Informal document **GRSP-58-08**
(58th GRSP, 7-11 December 2015,
agenda item 19)

Proposal for the 02 series of amendments to Phase 2 of Regulation No. 129 (Enhanced Child Restraint Systems)

Submitted by the expert from France*

Annex 2, insert at the end two new approval marks, to read:

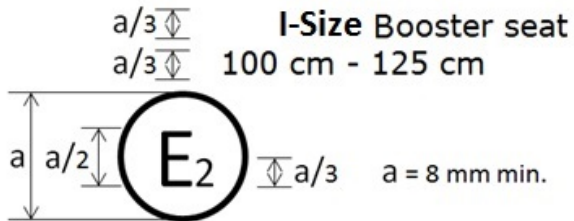
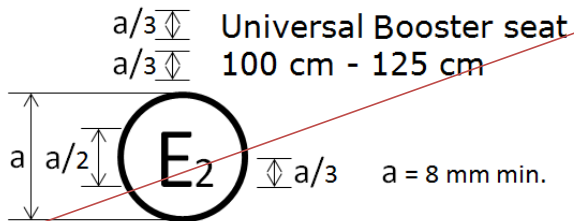
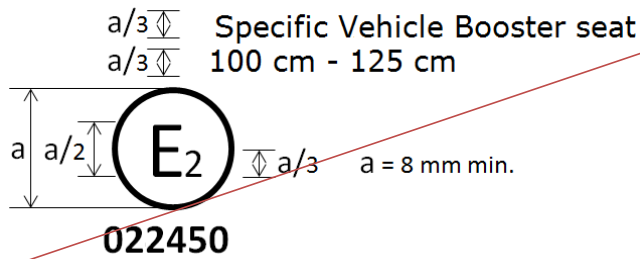
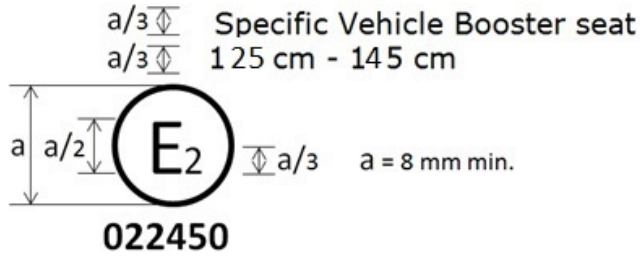
The Enhanced Child Restraint System bearing the above approval mark can be fitted in any I-Size booster seating position and used for the 100 cm - 125 cm size range; it is approved in France (E 2) under the number 022439. The approval number indicates that the approval was granted in accordance with the requirements of the Regulation concerning the approval of Enhanced Child Restraint Systems used on-board of motor vehicles as amended by the 02 series of amendments. In addition, the name of the regulation is to be identified on the approval mark followed by the series of amendment according to which the approval has been granted.

The Enhanced Child Restraint System bearing the above approval mark is a device not capable of being fitted in every vehicle but capable of being used for the 125 cm - 145 cm size range; it is approved in France (E 2) under the number 022450. The approval number indicates that the approval was granted in accordance with the requirements of the Regulation concerning the approval of specific vehicle booster seat Enhanced Child Restraint Systems used onboard of motor vehicles as amended by the 02 series of amendments. In addition the name of the regulation has to be identified on the approval mark followed by the series of amendment according to which the approval has been granted."

- Deleted: 105
- Deleted: 135
- Deleted: 012450
- Deleted: 01

Arrangements of the approval mark in combination with a module mark

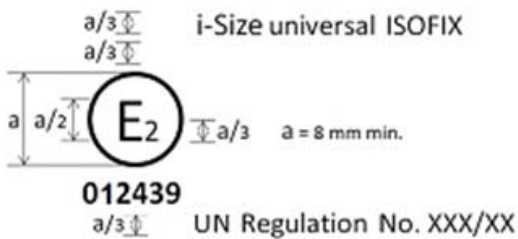
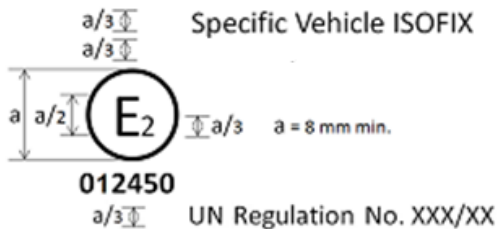
The Enhanced Child Restraint System bearing the above approval mark is a device, including module(s), capable of being fitted in any i-size compatible vehicle seating position. It is approved in France (E 2) under the number [022439](#). The approval number indicates that the approval was granted in accordance with the requirements of the Regulation concerning the approval of Enhanced Child Restraint Systems used onboard of motor vehicles as amended by the [02](#) series of amendments. In addition the name of the regulation has to be identified on the approval mark followed by the series of amendment according to which the approval has been granted.

Deleted: 012439

The Enhanced Child Restraint System bearing the above approval mark is a device, including module(s), not capable of being fitted in every vehicle. It is approved in France (E 2) under the number [022450](#). The approval number indicates that the approval was granted in accordance with the requirements of the Regulation concerning the approval of Specific vehicle ISOFIX Enhanced Child Restraint Systems used onboard of motor vehicles as amended by the [02](#) series of amendments. In addition the name of the regulation has to be identified on the approval mark followed by the series of amendment according to which the approval has been granted.

Deleted: 012450

"Annex 6 - Appendix 2

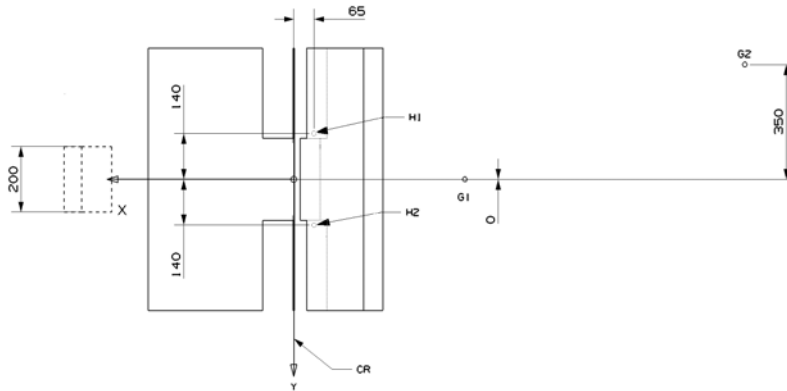
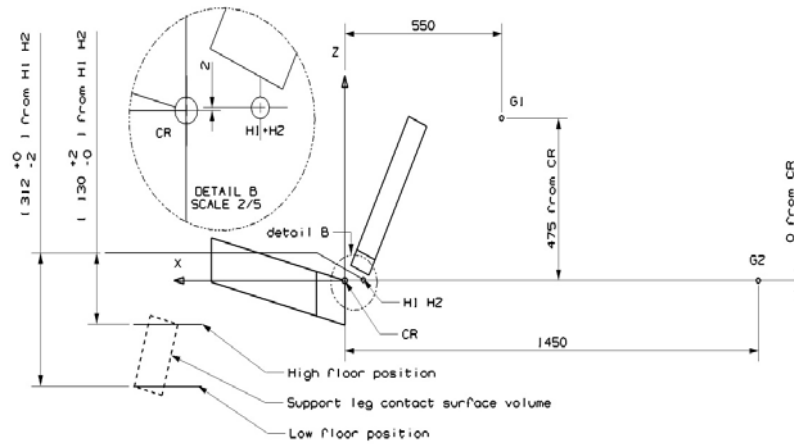
1. The anchorages shall be positioned as shown in the figure below.
2. Enhanced Child Restraint Systems in the i-Size "universal", "specific" and "restricted" categories shall use the following anchorage points: H₁ and H₂.

3. For testing of Enhanced Child Restraint Systems with top tether, the anchorage G₁ or G₂ shall be used.
4. In the case of Enhanced Child Restraint Systems utilising a support-leg, the Technical Service shall select the anchorages to be used according to paragraph 3. above and with the support-leg adjusted as specified in paragraph 7.1.3.6.3. of this Regulation.

Figure 3
Top View – Bench with belt anchorages (Tolerance general: ± 2 mm)

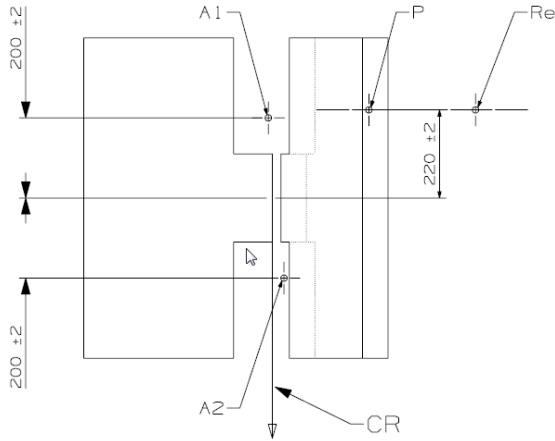
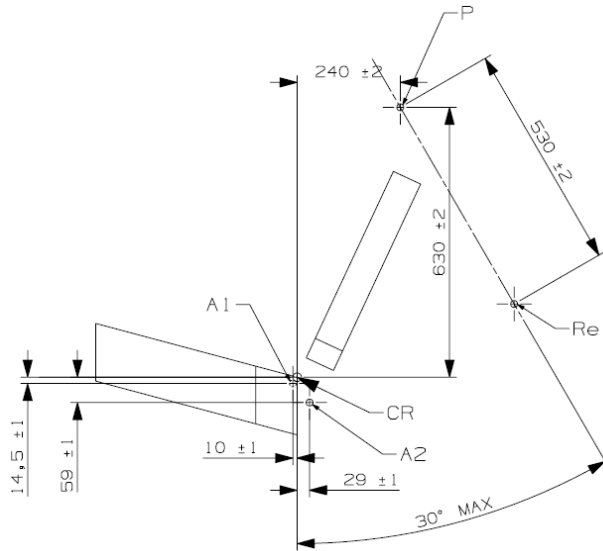
"Re" is located on the centre line of the retractor spool

"Re" is located on the centre line of the retractor spool"

"Annex 18

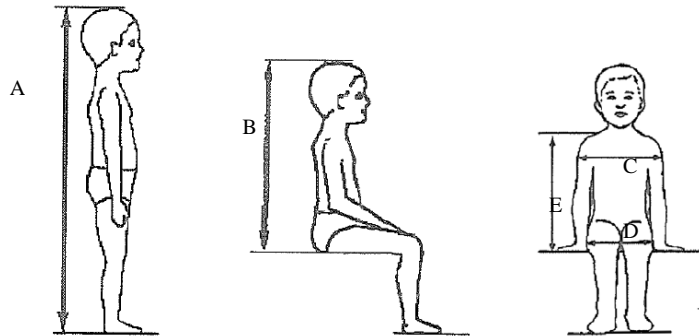
Stature cm	Minimum Sitting height cm	Minimum Shoulder breadth cm	Minimum Hip breadth cm	Minimum Shoulder height cm	Maximum Shoulder height cm
A	B	C	D	E1	E2
	95%ile	95%ile	95%ile	5%ile	95%ile
<40				27.4	
45	39.0	12.1	14.2	27.4	29.0
50	40.5	14.1	14.8	27.6	29.2
55	42.0	16.1	15.4	27.8	29.4
60	43.5	18.1	16.0	28.0	29.6
65	45.0	20.1	17.2	28.2	29.8
70	47.1	22.1	18.4	28.3	30.0
75	49.2	24.1	19.6	28.4	31.3
80	51.3	26.1	20.8	29.2	32.6
85	53.4	26.9	22.0	30.0	33.9
90	55.5	27.7	22.5	30.8	35.2
95	57.6	28.5	23.0	31.6	36.5
100	59.7	29.3	23.5	32.4	37.8
105	61.8	30.1	24.9	33.2	39.1
110	63.9	30.9	26.3	34.0	40.4
115	66.0	32.1	27.7	35.5	41.7
120	68.1	33.3	29.1	37.0	43.0
125	70.2	34.5 33.3	30.5 29.1	38.5	44.3

- Deleted: NA
- Deleted: NA
- Deleted: NA
- Deleted: NA
- Deleted: NA

<i>Stature cm</i>	<i>Minimum Sitting height cm</i>	<i>Minimum Shoulder breadth cm</i>	<i>Minimum Hip breadth cm</i>	<i>Minimum Shoulder height cm</i>	<i>Maximum Shoulder height cm</i>
<i>A</i>	<i>B</i>	<i>C</i>	<i>D</i>	<i>E1</i>	<i>E2</i>
	<i>95%ile</i>	<i>95%ile</i>	<i>95%ile</i>	<i>5%ile</i>	<i>95%ile</i>
130	72.3	35.7 33.3	31.9 29.1	40.0	46.1
135	74.4	36.9 33.3	33.3 29.1	41.5	47.9
140	76.5	38.1 34.2	34.7 29.6	43.0	49.7
145	78.6	39.3 35.3	36.3 30.8	44.5	51.5
150	81.1	41.5 36.4	37.9 32.0	46.3	53.3

"Annex 23

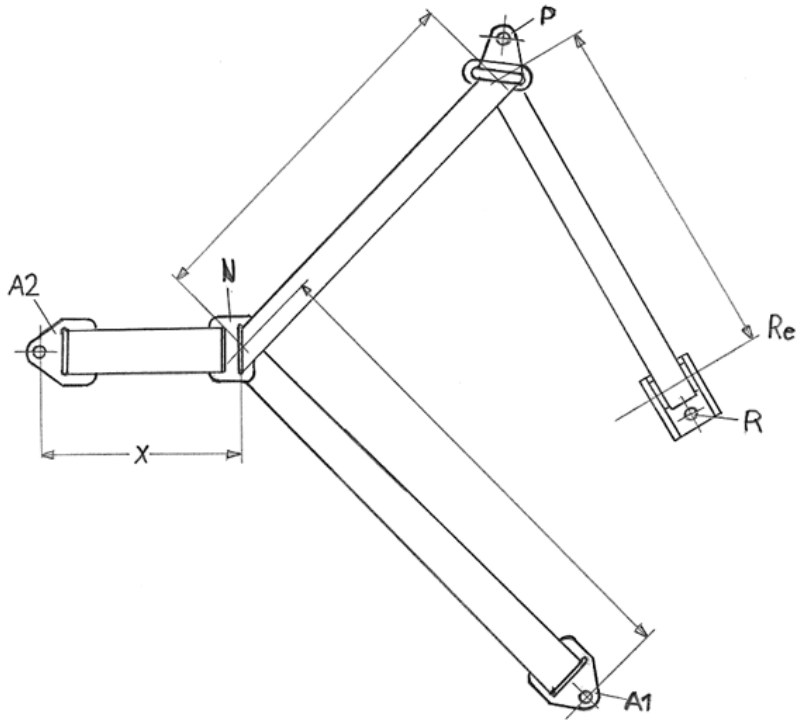
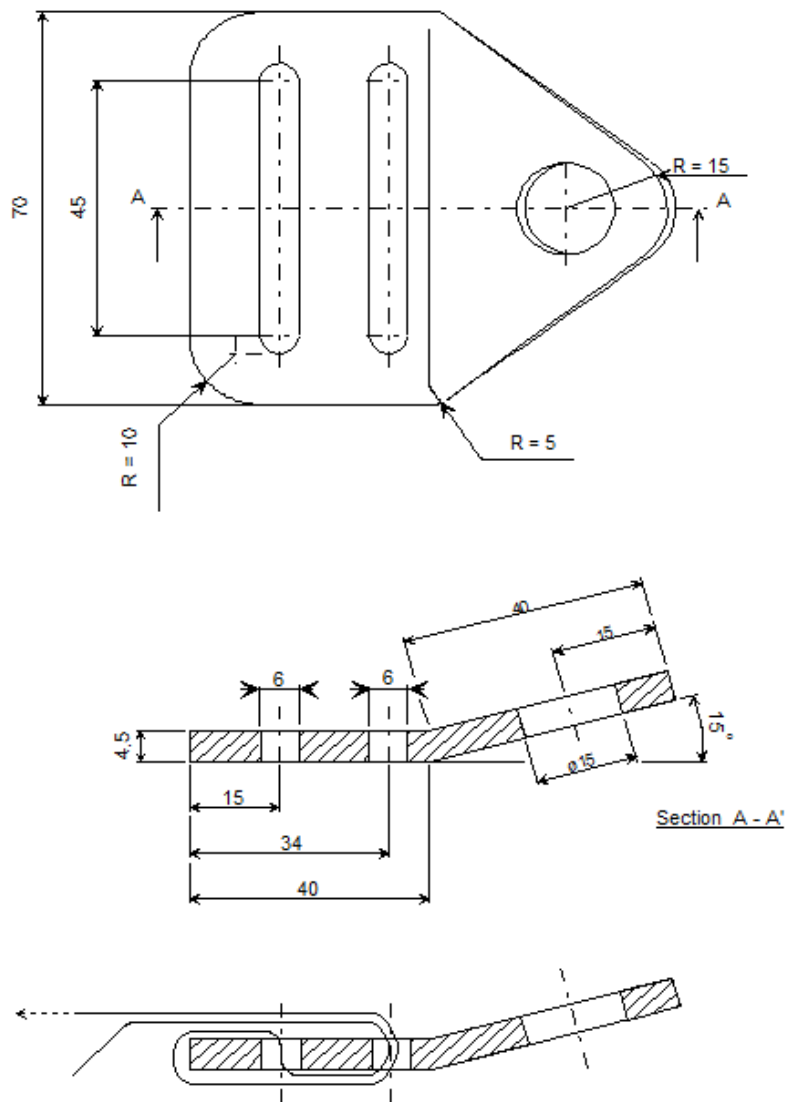
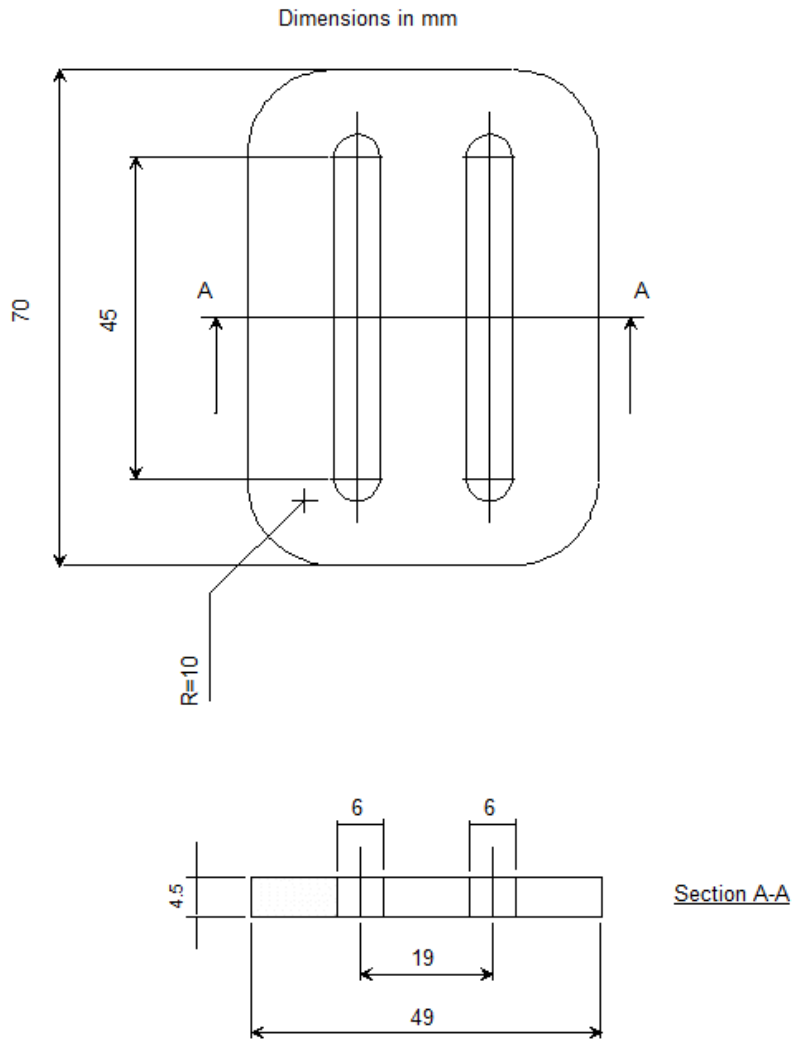
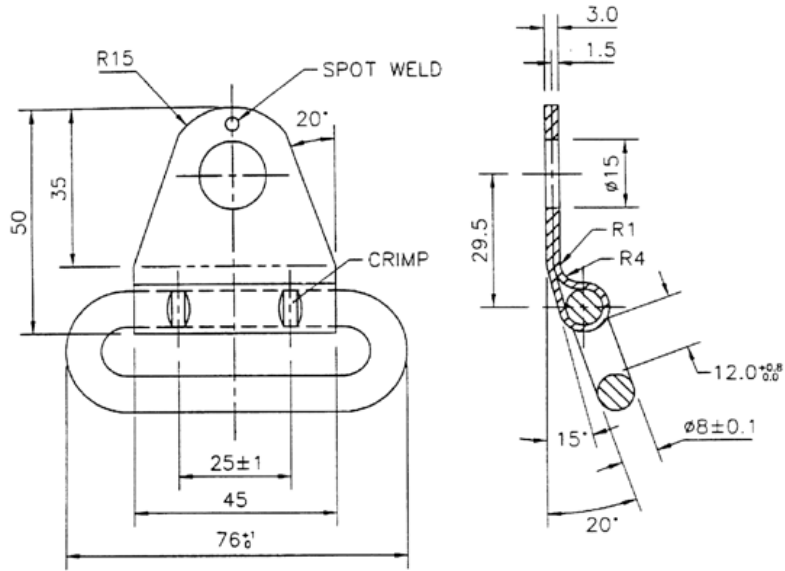
1. The safety-belt for the dynamic test and for the maximum length requirements shall be made according to the configuration shown in Figure 1. These are a three-point retracting belt system.

2. The three-point retracting belt has the following rigid parts: a retractor (R), a pillar loop (P), two anchorage points (A1 and A2) (see Figure 1), and a central part (N, in detail in Figure 3). The retractor shall comply with the requirements of Regulation No. 16 (paragraph 6.2.5.2.2.) for retraction force. The retractor spool diameter is 33 ± 0.5 mm [(example is given in Mutual Resolution No. 1 (M.R.1))].

3. The retracting belt shall be fitted to the anchorages on the test bench, described in Annex 6, Appendix 2 as follows:
 - (a) Belt anchorage A1 shall be fitted to trolley anchorages B0 (outboard);

- (b) Belt anchorage A2 shall be fitted to trolley anchorage A (inboard);
 - (c) Belt pillar loop P shall be fitted to trolley anchorage C;
- (d) Belt retractor R shall be fitted to trolley anchorage such that the spool centre line is positioned on Re.

The value of X in Figure 1 below is 200 ± 5 mm. The effective strap length between A1 and the centre line of the retractor spool Re (when the webbing is fully extracted including the minimum length of 150 mm for testing of Enhanced Child Restraint System shall be $[2820] \pm 5$ mm when measured in a straight line without load and on a horizontal surface. This length may be increased for the testing of restricted categories; for all categories with the Enhanced Child Restraint System installed, there shall be a minimum of 150 mm of strap length on the retractor spool.
4. The strap requirements for the belt as follows:
 - (a) Material: polyester spinnblack;
 - (b) Width: 48 ± 2 mm at 10,000 N;
 - (c) Thickness: 1.0 ± 0.2 mm;
 - (d) Elongation: 8 ± 2 per cent at 10,000 N.
